MCP98242 Rev. A1 Silicon Errata

The MCP98242 family devices that you have received conform functionally to the current Device Data Sheet (DS21996B), except for the anomalies described in this document.

The following typographic corrections and clarifications are to be noted for the latest version of the device data sheet (DS21996B):

FIGURE 1: Flow Chart.

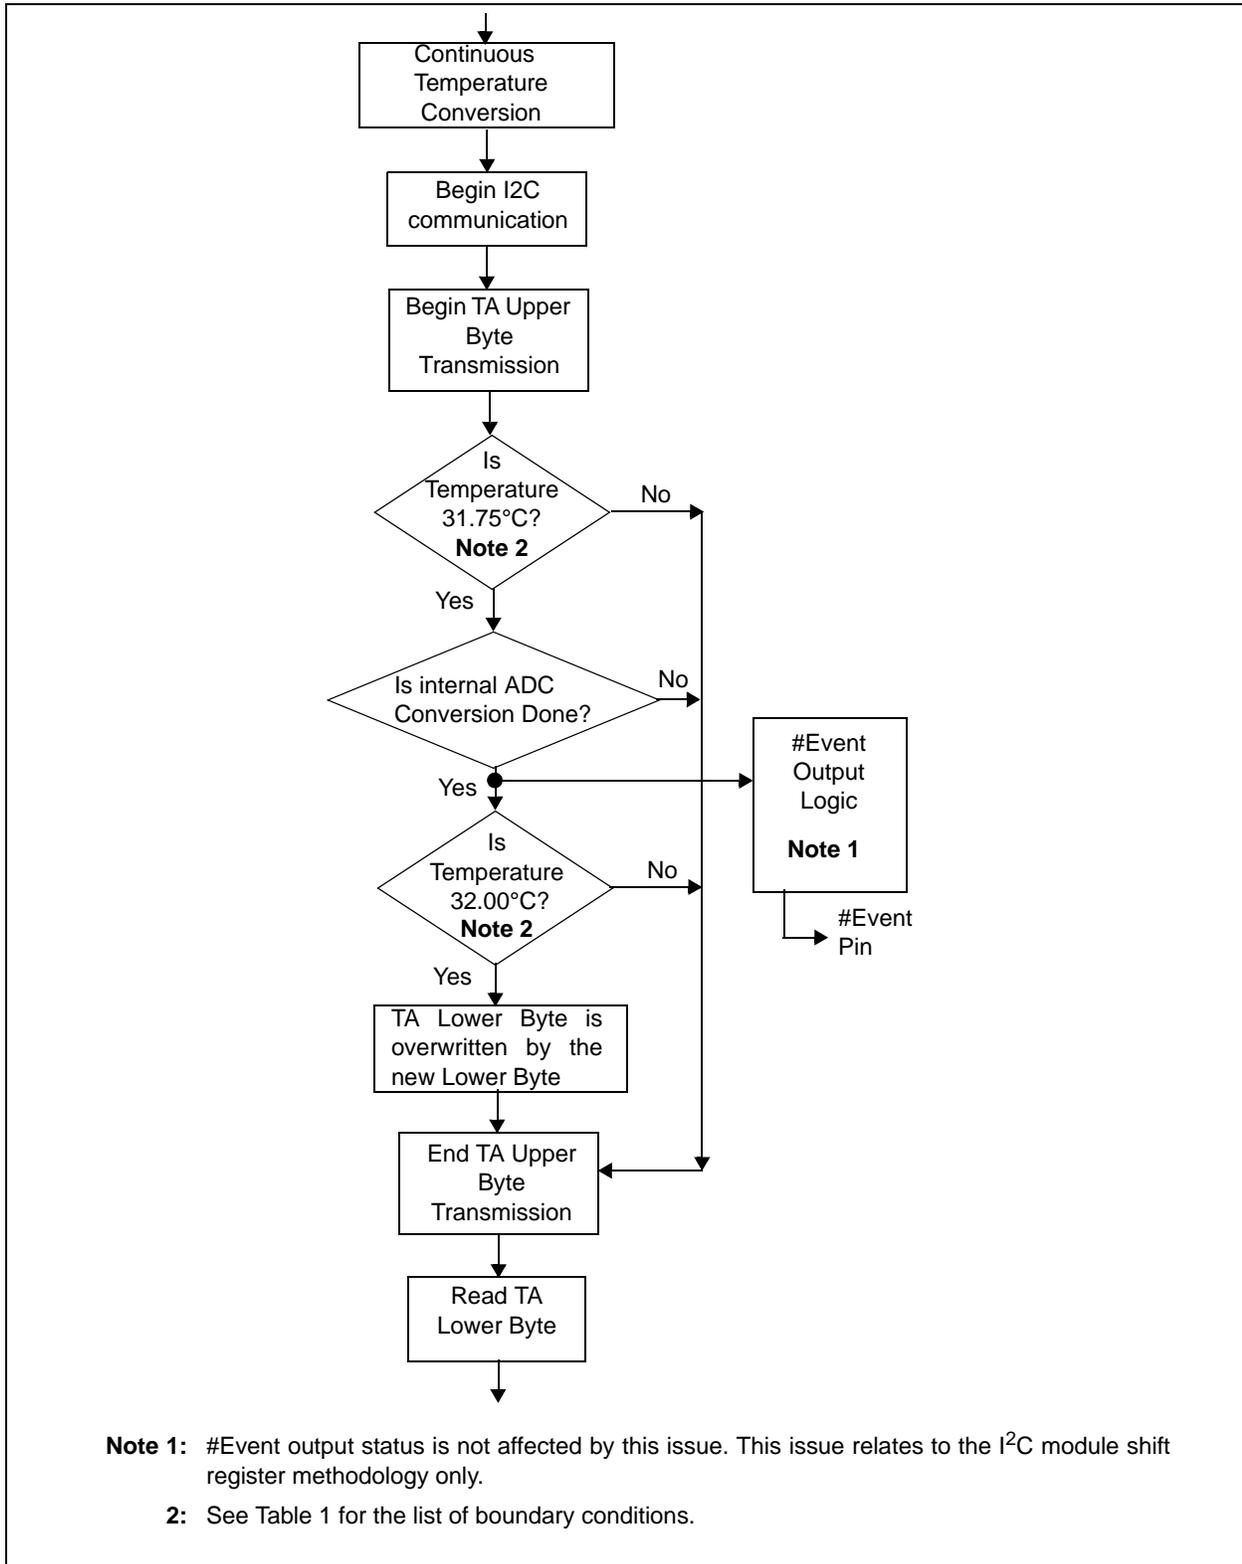
Under the specific boundary conditions listed below, the 2 byte temperature register T_A may contain temperature data $+16^\circ\text{C}$ or -16°C from the nominal temperature due to internal data synchronization issue.

- a) If the Lower Byte of the T_A register rolls up or down:
 - from `'1111 1100'b` to `'0000 0000'b`
 - from `'0000 0000'b` to `'1111 1100'b`
- b) If the internal ADC conversion completes ($T_{\text{CONV}} = 65 \text{ ms}$) while the Upper Byte is in transmission via the $I^2\text{C}$ bus.

Under these two conditions, the temperature reading may jump up or down by 16°C .

Byte 1 must be in $I^2\text{C}$ transmission for this issue to occur and the ADC must complete conversion while $I^2\text{C}$ is in communication. In addition, the ambient temperature must be at multiples of $16^\circ\text{C} \pm 0.25^\circ\text{C}$ for the temperature register to be partially overwritten.

Figure 1 shows flow diagram describing the specific conditions for the synchronization issue occurs. Table 1 shows a complete list of temperatures greater than 0°C.

If the ambient temperature read is within the host temperature limit, then do nothing. Otherwise, if the new temperature read is greater than or less than the previous temperature data by exactly 16.00°C, then perform a Repeat Read to receive the correct temperature data. There is a 0% probability that the Repeat Read data would be corrupted, if the Repeat Read is performed within T_{CONV} (65 ms). If a Repeat Read is performed after 65 ms then there is a greater than 0% probability that the next conversion would also be corrupt by ±16.00°C as stated in Table 1. In this case, disregard this reading and perform a Repeat Read and compare the result with the last known good reading.

Devices on or after date code 0847 correct this issue. **The Device ID/Revision Register for these parts is set to 0x2000 hex.**
